ADDENDUM NO. FOUR (4)

PROJECT:
GCSC SOFTBALL
COMPLEX

ITB # 6-2016/2017

SHEET
A8.10

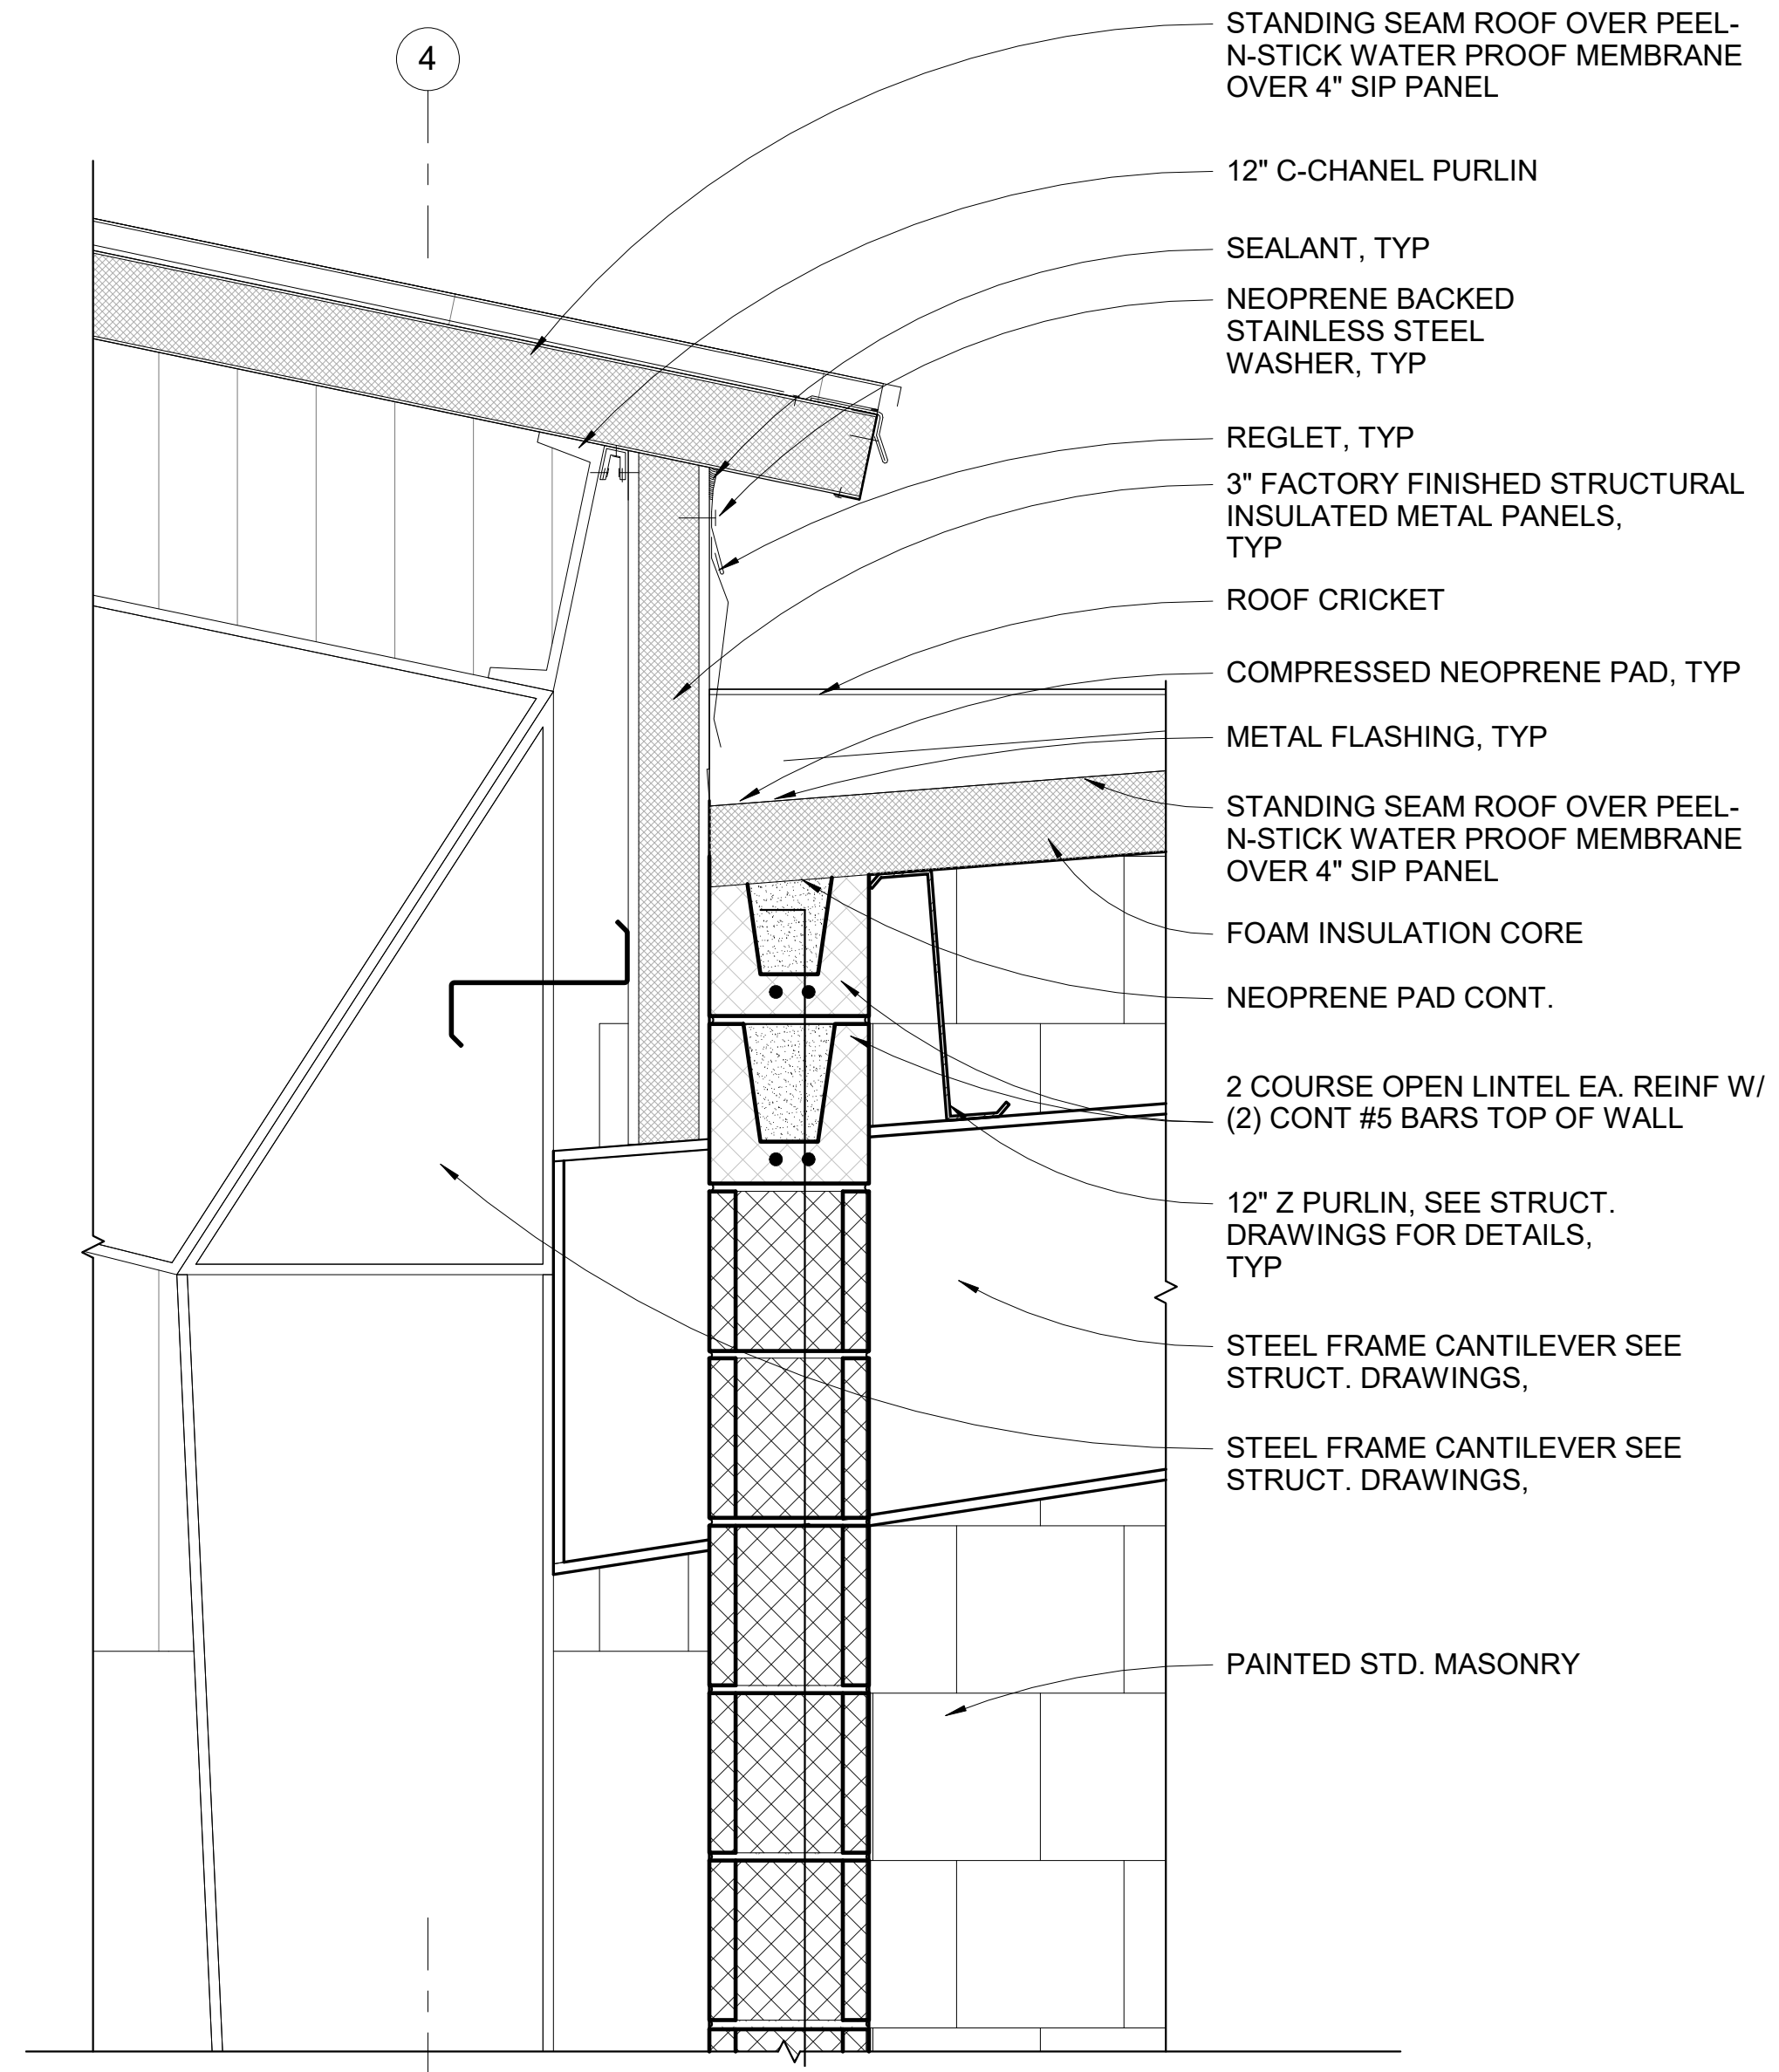
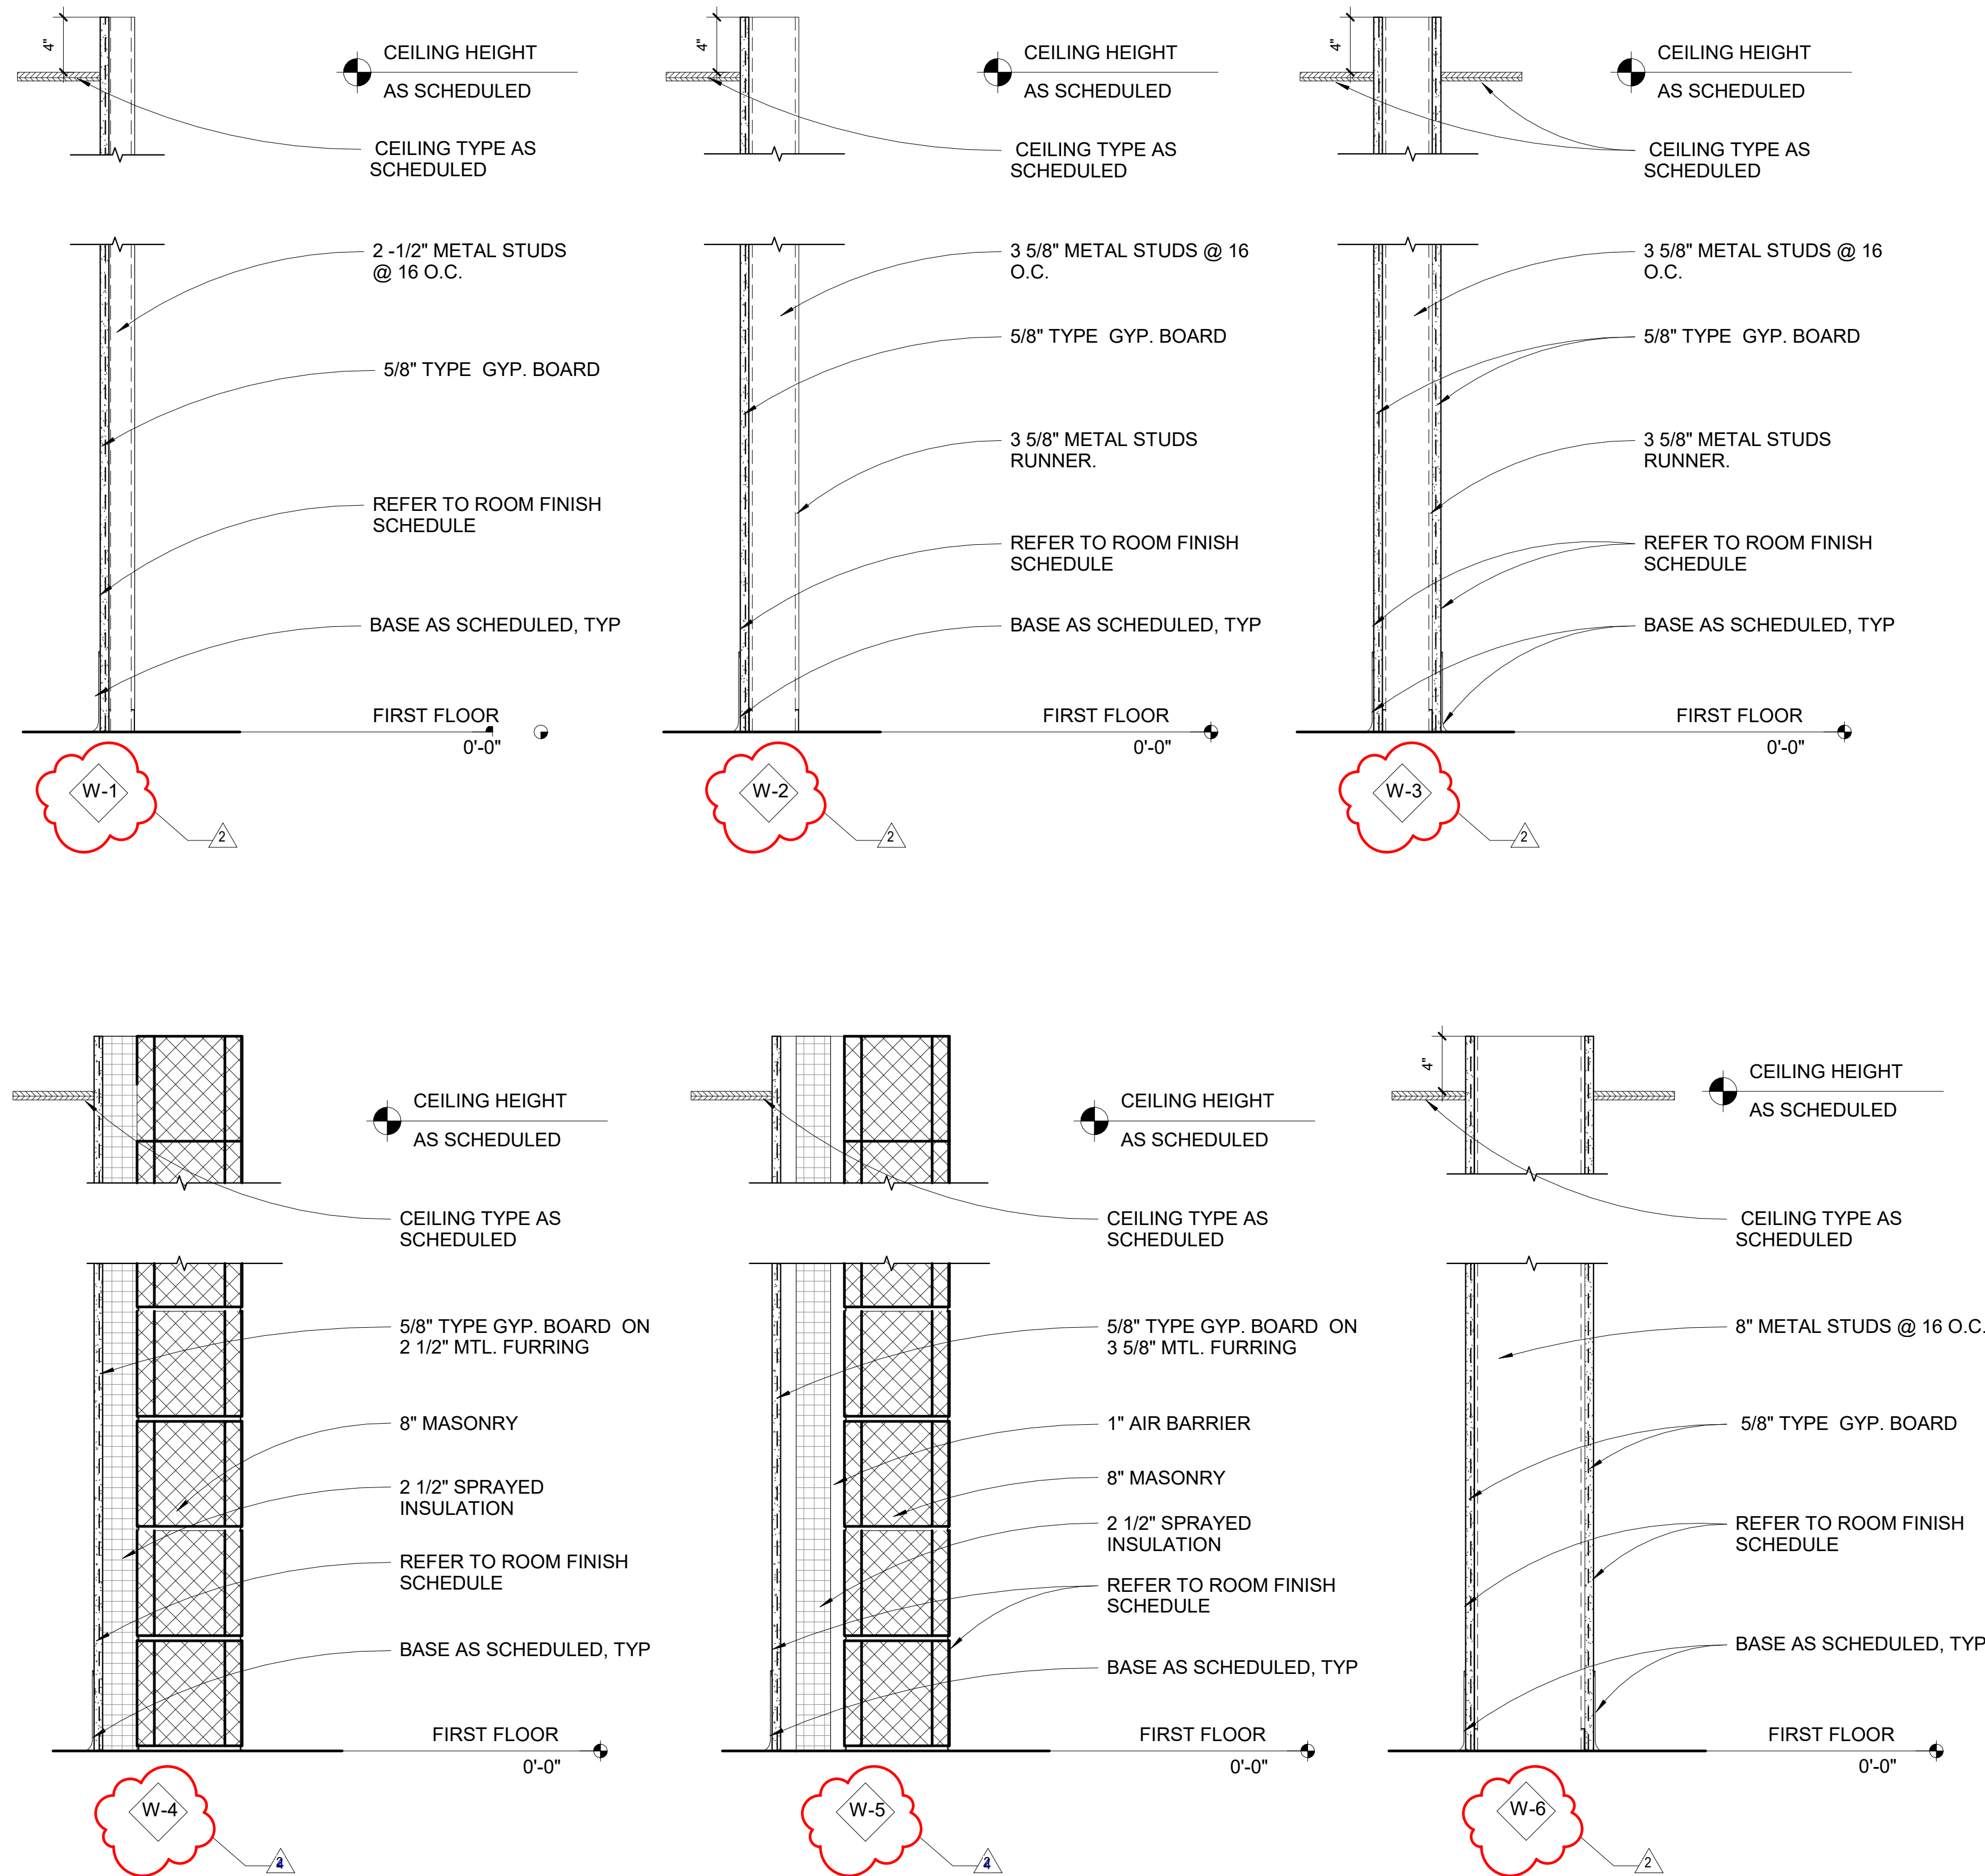
- Item No. 1A: Refer to Drawing Sheet A1.0: Regarding the 20' x 26' Pre-engineered STORAGE metal building, the attached cut-sheet represents an acceptable type product with the overhead metal door.
- Item No. 2A: Refer to Drawing Sheet A8.10: Regarding the wall composition, W-4 & W-5, and placement of the insulation within those wall types.
